CNL-17-088

Clinch River Nuclear Site
NRC Docket No. 52-047

Subject: Submittal of Supplemental Information Related to the Environmental Audit in
Support of Early Site Permit Application for Clinch River Nuclear Site

1939 Clinch River Site Aerial Photograph

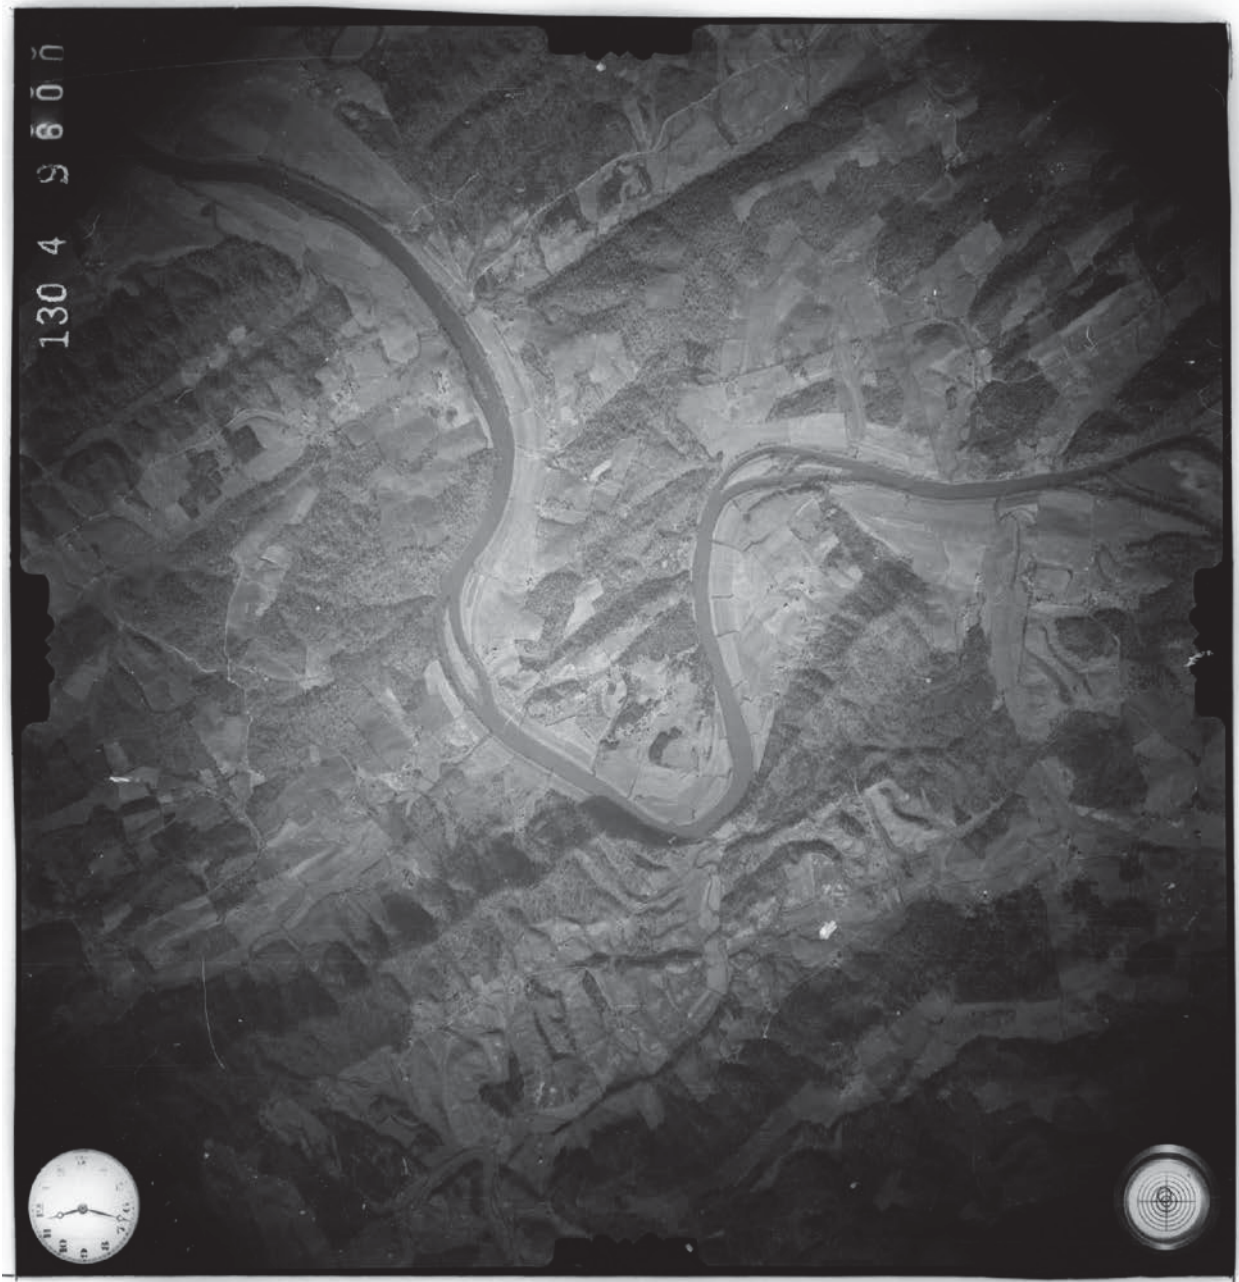
During the audit, the NRC requested that the high resolution digital scan of the 1939 aerial photograph presented be provided on the docket. The NRC also requested that, if available, TVA provide high resolution digital scans of aerial photographs of Sites 2 and 8, and high resolution digital scans of aerial photographs during construction period of the Clinch River Breeder Reactor Project (CRBRP). Attachment 1 to this enclosure provides the 1939 Clinch River Site Aerial Photograph, a 1939 Site 2 and a 1939 Site 8 Aerial Photograph, and aerial photographs of the CRBRP from 1983 and 1984.
